## Product Change Notification / ALAN-15FPNL260

eSign# E000077600 Final Notice: Implement change of memory density from 4GB to 2GB on selected Microsemi M2GLxx, RT4Gxx and 5962-16xx FPGA device families available in various packages.

### Subject: RTG4, SmartFusion2, and IGLOO2 DDR Controller Memory Density Support

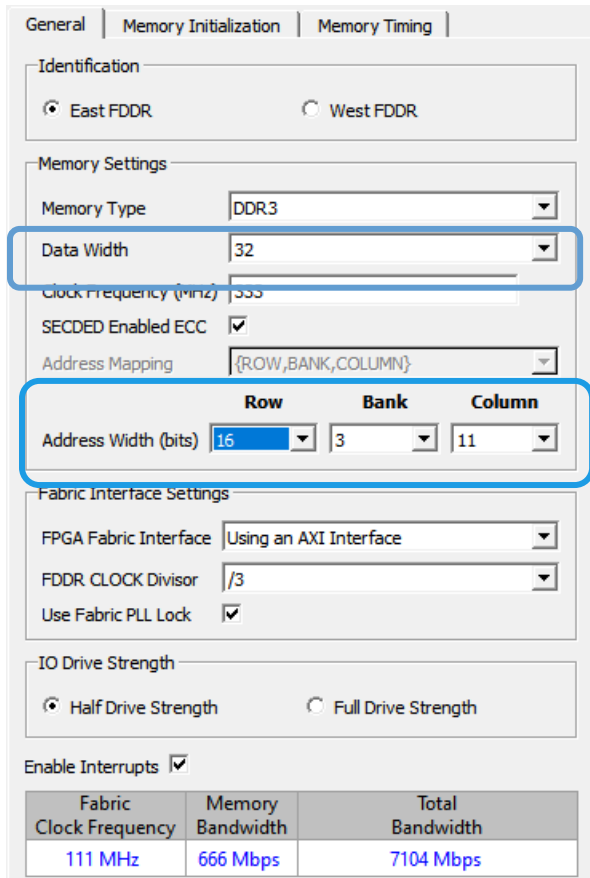
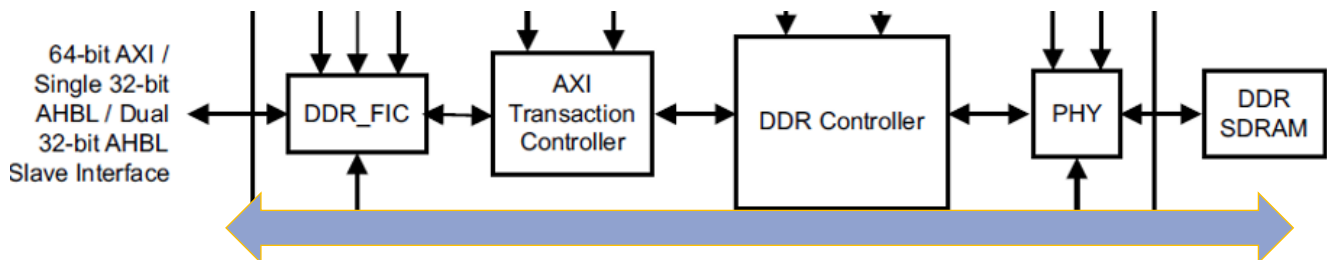
FDDR/MDDR configurations that do not map the MSB of the 32-bit AXI address to the DDR memory address are not affected. In other words, if the AXI address does not exceed a 2GB address space, there is no application impact. Designs with memories greater than 2GB can only access up to 2GB of the memory.

**How to assess if configuration of memory controller is addressing more than 2GB.**

From the Libero Configurator, below

- Total LPDDR/DDR2/DDR3 address bits = Row+ Bank + Column
- Total LPDDR/DDR2/DDR3 addressable data bits =  $2^{\text{address bits}} * \text{(word size aka Data Width)}$
- Total LPDDR/DDR2/DDR3 addressable bytes =  $(\text{addressable data bits})/8$

**Example: Row = 16, Bank = 3, Column = 11**

Total LPDDR/DDR2/DDR3 address bits = 30

Total LPDDR/DDR2/DDR3 addressable data bits =  $2^{30} * 32 = 34,359,738,368$

Total LPDDR/DDR2/DDR3 addressable bytes =  $34,359,738,368/8 = 4,294,967,296 = 4GB$

No action is required for designs that do not address more than 2GB with the FDDR/MDDR controller hard-IP blocks in RTG4, IGLOO2, and SmartFusion2.

For designs experiencing the functional issue described above, or those planning to address more than 2GB, the following conditions must be reviewed:

- Ensure that the Libero FDDR/MDDR configuration does not map the AXI address to a 4GB DDR memory address.

- Designs with memories greater than 2GB can only access up to 2GB of the memory.
